# Access Compliance Report

## Public Rights-of-Way

Intersection ID: 7091	Main Street: BROOKSHIRE_BV	Cross Street: HOVIS_RD	Location:	E
ADA ID: D4F87A008E41	Ramp Type: Perp	Initial Pass/Fail: Fail	Overall Compliance: No	Severity Score: 8.75
Codes/Mitigation Info/Possible Solution		Field Measurements/Component Compliance

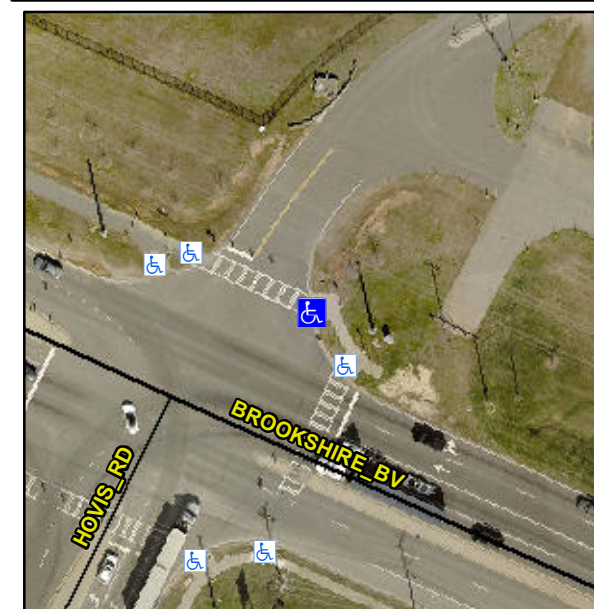
Compliance	Description	Data	Compliance	Description	Data
N/A	Ramp Length (in)	96.0	Yes	Ramp Slope (%)	6.6
No	Ramp Width (in)	40.5	Yes	Ramp XSlope (%)	1.0
N/A	Flare Type LT	N/A	N/A	Flare Type RT	N/A
N/A	Flare Slope LT (%)	N/A	N/A	Flare Slope RT (%)	N/A
N/A	Flare Traversable LT?	N/A	N/A	Flare Traversable RT?	N/A
N/A	Landing Length (in)	N/A	N/A	DWS Provided?	N/A
N/A	Landing Width (in)	N/A	N/A	DWS Contrast?	N/A
N/A	Landing Slope (%)	N/A	N/A	DWS Length (in)	N/A
N/A	Landing X Slope (%)	N/A	N/A	DWS Full Width?	N/A
N/A	Landing Curb? (Y/N)	N/A	N/A	DWS Offset (in)	N/A
N/A	Shared Landing?	N/A			
N/A	Gutter Ponding?	N/A	N/A	Gutter Slope (%)	N/A
N/A	Gutter Lip Ht (in)	N/A	N/A	Gutter X Slope (%)	N/A
N/A	Painted X Walk1?	Yes	N/A	Painted X Walk2?	N/A
	X Walk 1 Direction	To NW		X Walk 2 Direction	N/A
N/A	X Walk 1 Width (in)	113.0	N/A	X Walk 2 Width (in)	N/A
	X Walk 1 Slope (%)	1.7		X Walk 2 Slope (%)	N/A
	X Walk 1 X Slope (%)	1.9		X Walk 2 X Slope (%)	N/A

**Remove & Replace Entire Ramp.**
